SERVICE DIRECTIVE BULLETIN NO. T-028

Revision 2

1. SUBJECT: Turbine Engine Assembly - Steady State Operation Avoidance Range Limit
2. MODEL: TH-28, 480, and 480B
3. EFFECTIVITY: All Serial Numbers
4. BACKGROUND:

Figure 1. TH-28/480 Dual Tach - Aircraft Not Equipped With Increased RPM Kit, P/N 4230002

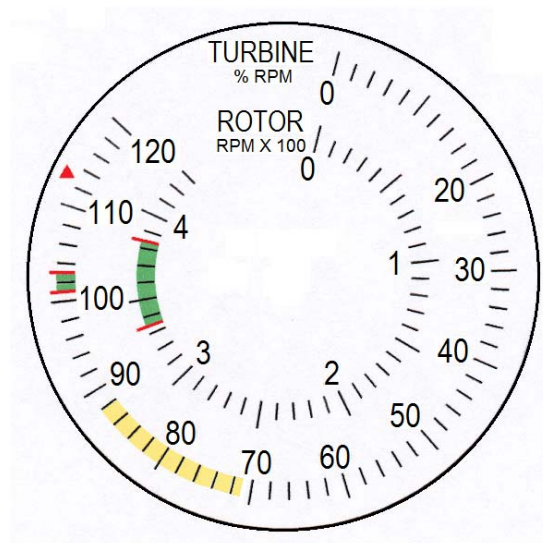
- 6.4.1 Apply a yellow arc range marking on the face glass of the dual tachometer that corresponds from 71% N₂ to 88% N₂ (TURBINE % RPM). Refer to paragraph 6.5 for sources of range marking decals. Refer to Figures 1, 2, or 3 for the location of the range marking.
- 6.4.2 Apply a clear coat finish (finger nail polish or equivalent) over the range marking.
- 6.4.3 Apply a torque stripe/slippage mark between the glass face and the instrument case at the 6 o'clock position.
